PROPOSED 2022 MUELLER PUD **ADMINISTRATIVE AMENDMENTS**

Presentation to RMMA Plan Implementation Advisory Commission November 15, 2022

PROPOSED 2022 PUD AMENDMENTS

UNIT REALLOCATION

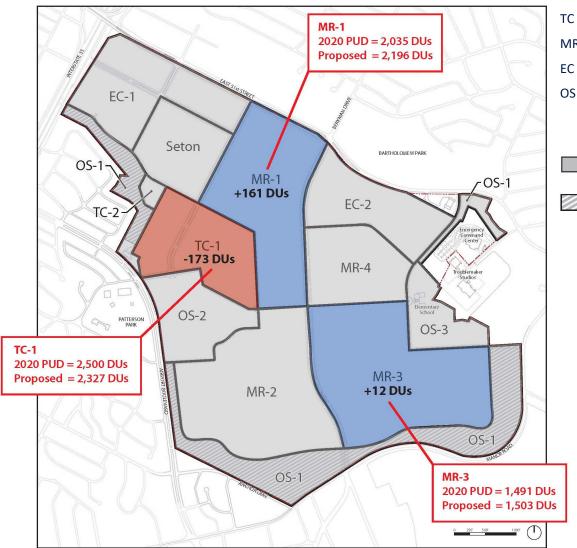
- Redistribution of Residential Units within PUD's Maximum Densities
- Clarify that Accessory Dwelling Units (ADUs) are allowed to be built on Row House lots
